TECHNICAL SERVICE BULLETIN

12MY-16MY 195, 195h COE STABILITY UPGRADE

Group:	48-Suspension
Bulletin No.:	SB-15-028
Issue Date:	06-11-2015

REPAIR PROCEDURE A

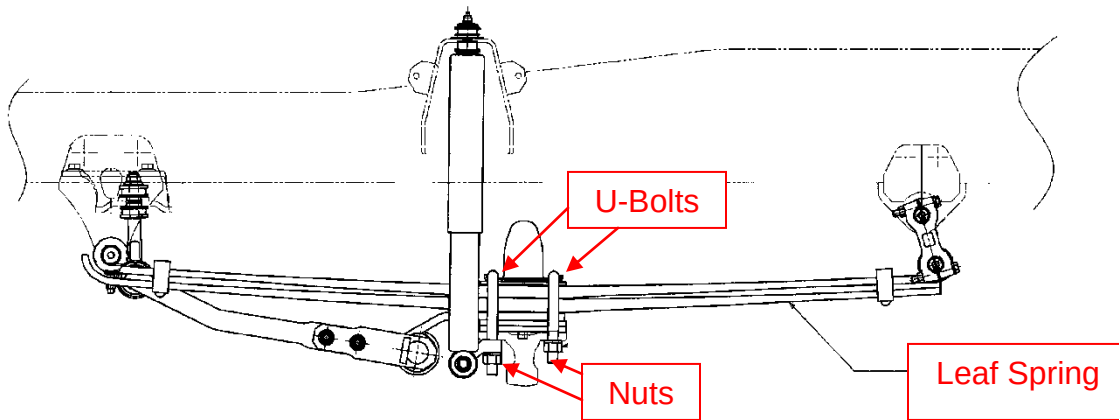
Front suspension modification for vehicles with VIN number beginning in JHH built before March 4, 2015.

NOTICE: This repair procedure requires the removal and discarding of both front leaf spring assemblies. These original front leaf spring assemblies have a weight rating of 3,100kg. This TSB directs you to install new front leaf spring assemblies which have an increased weight rating of 3,300kg. The increased weight rating of the front spring leaf assemblies does **NOT** change the overall GVWR (Gross Vehicle Weight Rating) of the vehicle.

1. Raise and support the front of the vehicle using jack stands. Remove and discard the driver's side front leaf spring as outlined in the Suspension section of the Chassis Workshop Manual. The 2 U-bolts and 4 U-bolt nuts which secure the leaf springs to the front axle must be discarded.

2. Install the replacement front driver's side leaf spring (Part No. 4811037Y60) into the vehicle using new U-bolts and new U-bolt nuts following the procedure in the Chassis Workshop Manual Suspension section.

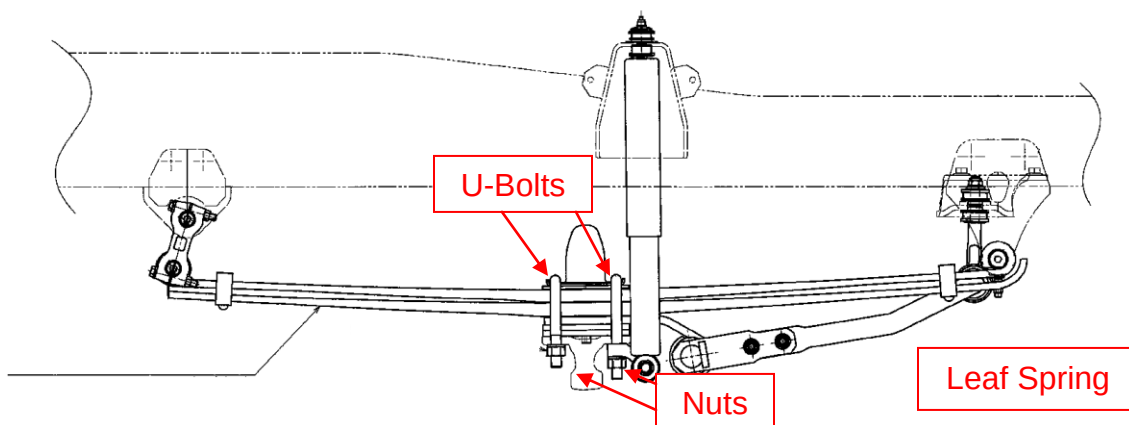
3. Remove and discard the passenger side front leaf spring as outlined in the Suspension section of the Chassis Workshop Manual. The 2 U-bolts and 4 U-bolt nuts which secure the leaf springs to the front axle must be discarded.

4. Install the replacement front passenger side leaf spring (Part No. 4811037Y70) into the vehicle using new U-bolts and new U-bolt nuts following the procedure in the Chassis Workshop Manual Suspension section. Lower the front of the vehicle onto the ground.

REPAIR PROCEDURE B

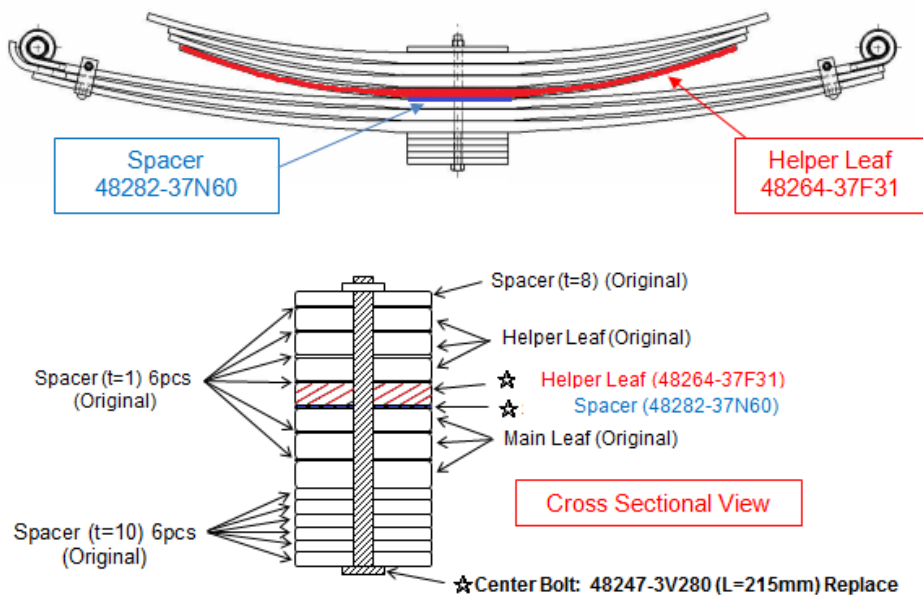
Rear suspension modification for all subject vehicles with updated front springs

NOTICE: For vehicles with VIN number beginning in JHH built before March 4, 2015, repair Procedure B should not be performed unless the customer has assessed vehicle handling after Repair Procedure A has been performed, and the customer still feels that body roll is excessive.

1. Raise and support the rear of the vehicle using jack stands. Remove the driver's side rear leaf spring from the vehicle as outlined by the Suspension section of the Chassis Workshop Manual. Discard the 2 U-bolts and 4 U-bolt nuts which secure the leaf spring to the axle. Remove and discard the center bolt from the leaf spring as outlined in the manual. Discard the center bolt and center bolt nut. Retain the rear leaf spring for reinstallation. The spring pack will be modified to add an additional helper leaf and spacer.

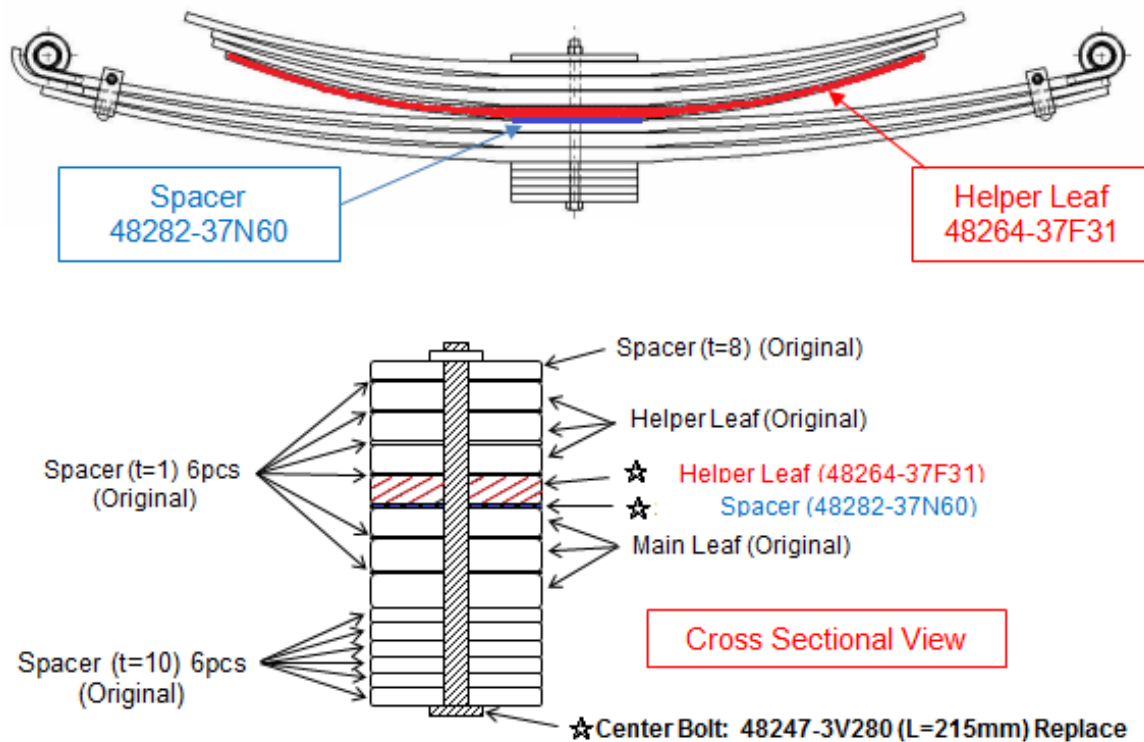
2. Assemble the spring pack referring to the diagram below for proper placement of the new helper leaf and spacer. Install the new center bolt (Part No. 482473V280) and center bolt nut (Part No. 482840W070) following the procedure in the Chassis Workshop Manual Suspension section.

- Reinstall the driver's side rear leaf spring assembly with the new helper leaf and spacer into the vehicle following the procedure in the Chassis Workshop Manual using new U-bolts and new U-bolt nuts.

- Remove the passenger side rear leaf spring from the vehicle as outlined in the Suspension section of the Chassis Workshop Manual. Discard the 2 U-bolts and 4 U-bolt nuts which secure the leaf spring to the axle. Remove the center bolt from the leaf spring as outlined in the manual. Discard the center bolt and center bolt nut. Retain the rear leaf spring for reinstallation. The spring pack will be modified to add an additional helper leaf and spacer.

- Assemble the spring pack referring to the diagram below for proper placement of the new helper leaf and spacer. Install the new center bolt (Part No. 482473V280) and center bolt nut (Part No. 482840W070) following the procedure in the Chassis Workshop Manual Suspension section.

- Reinstall the passenger side rear leaf spring assembly with the new helper leaf and spacer into the vehicle following the procedure in the Chassis Workshop Manual using new U-bolts and new U-bolt nuts.

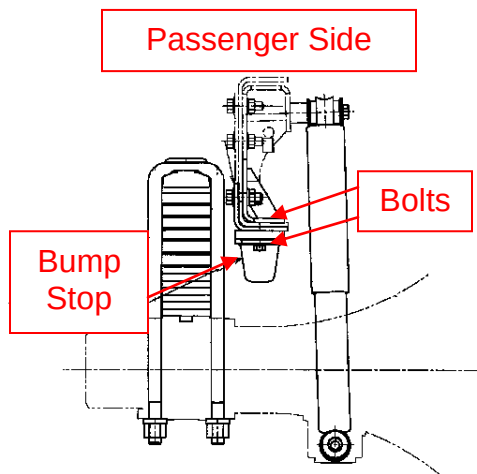
7. Remove and discard the 2 bolts retaining the left rear and right rear bump stops onto the frame. Discard the left rear and right rear bump stops.

NOTICE: The passenger side is shown in the illustration to the right. The driver's side, not shown, is similar.

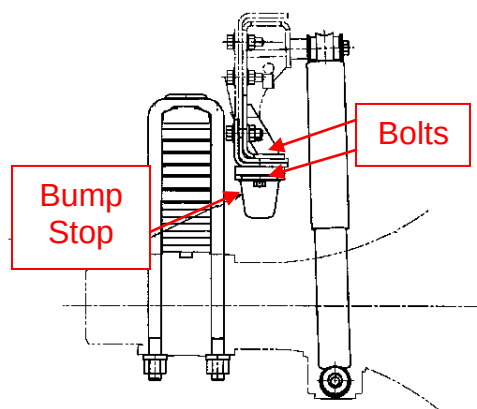
8. Install the new left rear and right rear bump stops (Part No. 4834437420). Install the 2 bolts retaining the left and the right rear bump stops onto the frame (Part No. 9155281020). Tighten the 2 bolts to the specified torque.

NOTICE: The passenger side is shown in the illustration to the right. The driver's side, not shown, is similar.

Specified Torque: 29 lb-ft (39 Nm)
